**REQUEST** Current Zoning: R-3 (single family residential)  
Proposed Zoning: UR-2(CD) (urban residential, conditional)

**LOCATION** Approximately 7.5 acres located on the west side of Elm Lane, south of Camfield Street.  
(Council District 7 - Driggs)

**SUMMARY OF PETITION** The petition proposes a residential infill development, off of Elm Lane south of I-485 and behind two existing religious institutions, containing up to 61 single family attached townhomes.

**Proposed Request Details**

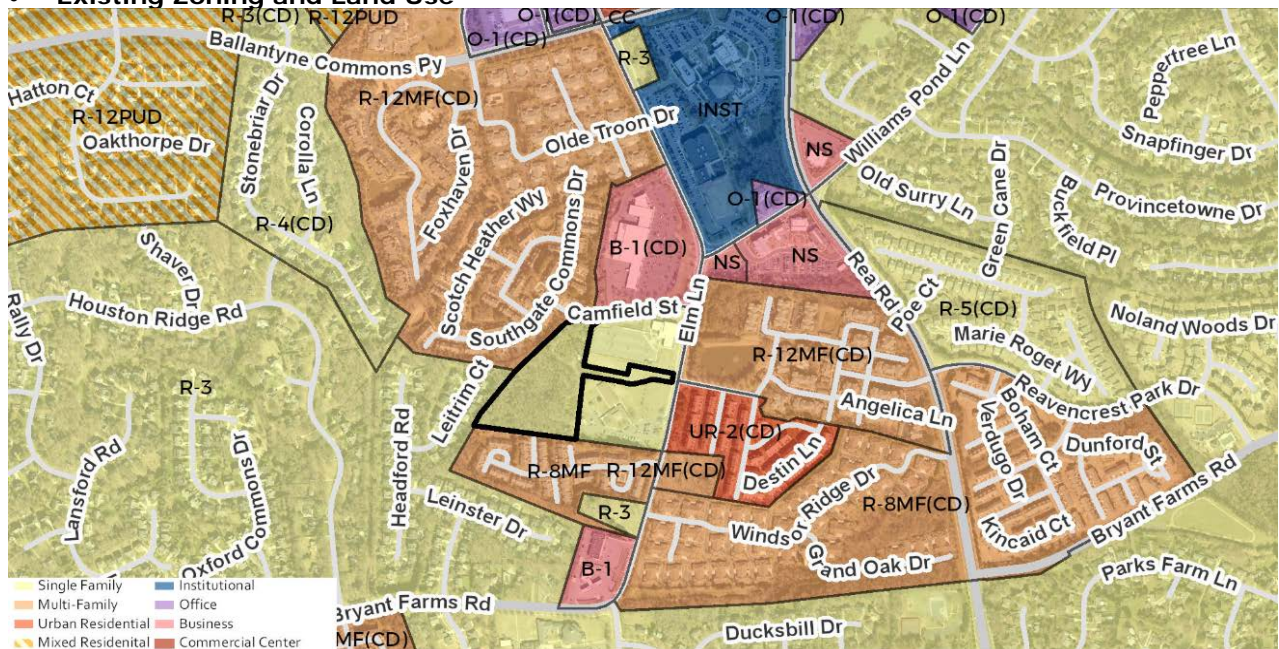
1. Revise the site plan to add a note specifying all transportation improvements will be approved and constructed before the site's first building certificate of occupancy is issued. The petitioner may phase transportation improvements if said improvements and phasing are explicitly described in site plan notes.

2. Submit a tree survey for all trees two (2) inches in diameter at breast height (DBH) or larger located in the public right-of-way. Tree survey may be completed by landscape architect, surveyor, or other land development professional.

3. Revise the site plan to show tree save calculations on the site map. Site is in a wedge and will be required to provide 15% tree save area based on gross acreage. 15% of 7.5 acres = 1.125 acres tree save. Tree save must contain existing healthy tree canopy. Tree save must be 30' width minimum.

4. Show and label a proposed access drive for the cell tower.
